<b>CITY OF WESTMINSTER</b>			
<b>PLANNING APPLICATIONS COMMITTEE</b>	<b>Date</b> <b>18 April 2017</b>	<b>Classification</b> For General Release	
<b>Report of</b> Director of Planning		<b>Ward(s) involved</b> Lancaster Gate	
<b>Subject of Report</b>	<b>1 Queensborough Mews, London, W2 3SG,</b>		
<b>Proposal</b>	Removal of Condition 4 of planning permission dated 28 September 2015 (RN: 15/06025) which varied Condition 1 of planning permission dated 01 May 2015 (RN: 15/01872) for erection of single storey building to garden (fronting Queensborough Terrace) to house electricity substation; namely to remove the requirement for the new doors facing Queensborough Terrace to be clad with timber and to retain the metal louvred doors installed.		
<b>Agent</b>	Mr Ben Radford		
<b>On behalf of</b>	Mrs Judith Wells		
<b>Registered Number</b>	17/00195/FULL	<b>Date amended/ completed</b>	16 January 2017
<b>Date Application Received</b>	10 January 2017

<b>Historic Building Grade</b>	Unlisted		
<b>Conservation Area</b>	Bayswater

**Reference:** 17/00195/FULL

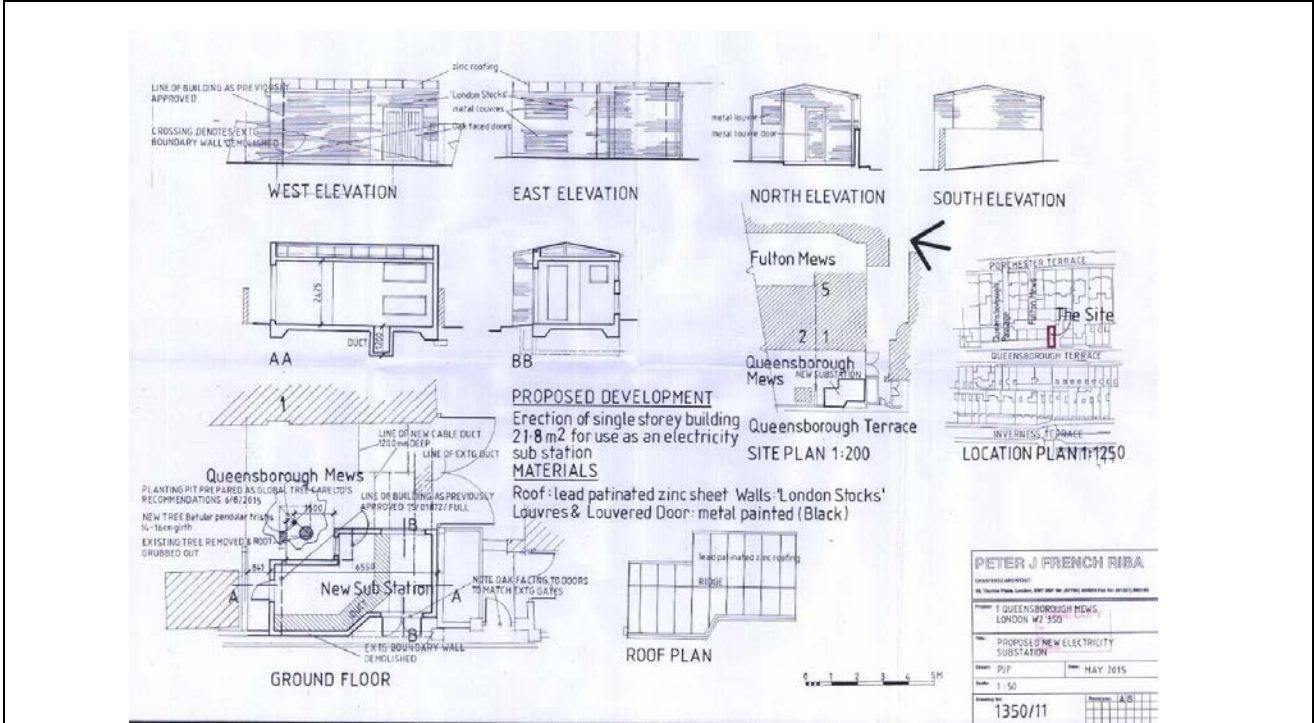
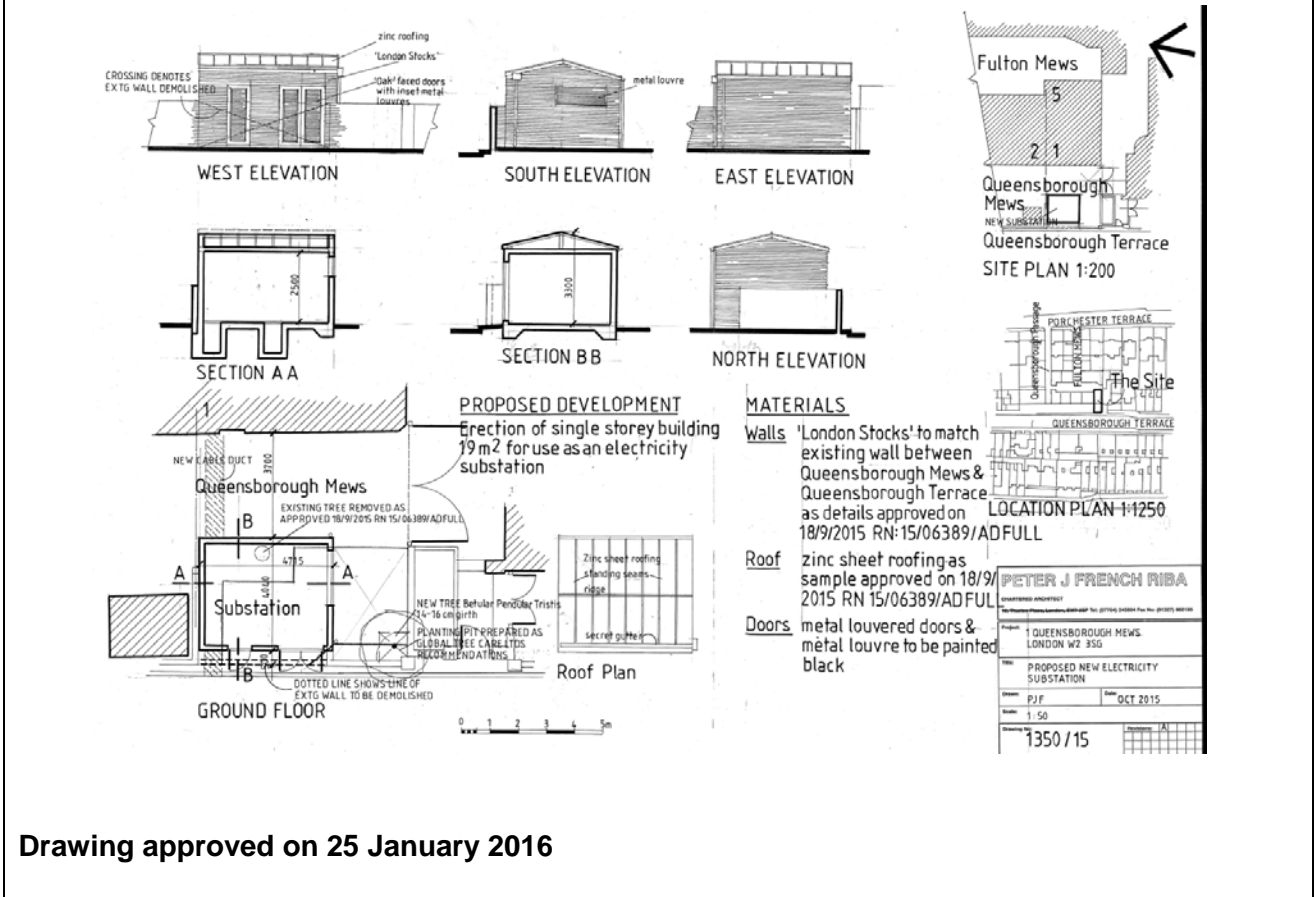
Objections to the current application have been received from local residents on the grounds that the current proposals seek to further reduce the design quality of the substation and that there is insufficient justification within the application to substantiate the argument for the design alteration. The objectors note the requirement for timber doors was imposed on the original permissions to ensure appropriate materials were introduced within the Conservation Area and to prevent an 'industrial aesthetic' which was considered to be inappropriate in this location and why therefore should the City Council's view alter.

The applicant has clarified that due to UKPN regulations the requirement to have fully timber doors could not be achieved (as required under an earlier permission) and therefore under the January 2016 permission a compromise was reached which allowed for inset metal louvres within timber doors. As installed, the doors are fully metal. Further clarification was requested from the applicant with regards to why the timber doors with inset metal louvres couldn't be achieved. UKPN state that any timber on the building presents a fire risk and any potential risks should be designed out. If a fire was to break out inside the substation the timber on the external elevation could catch and present greater danger.

Whilst the introduction of cladding was not disputed at the time of the previous application by UKPN, it has since been established that the metal doors cannot be compromised with fixings and therefore the only way of securing the timber to the doors would be with glue. Notwithstanding the need to 'design out' fire risks, the methodology and resultant appearance of gluing the cladding on could be achieved, however the longevity of this approach is questioned and it is considered that once the cladding is in place for a while, it could become tatty and unsightly. The long term maintenance of the cladding could not be secured. This would result in a feature which detracts from the overall appearance of the area.

It is noted that having metal doors facing Queensborough Terrace was not the intended design and that alterations and amendments have historically been made which dilutes the consciously designed substation. However the resultant appearance of the substation, if constructed with metal doors and cladding stuck on in accordance with UKPN regulations, would not have achieved the highest standard of design required to ensure this structure complimented its setting. In this instance given the justification given by UKPN, having black painted metal louvred doors, which are easy to maintain is considered to be the most pragmatic approach to preserve the character and appearance of the conservation area in the long term.

4 The louvered doors and louvered panels shall be painted black and maintained that colour.
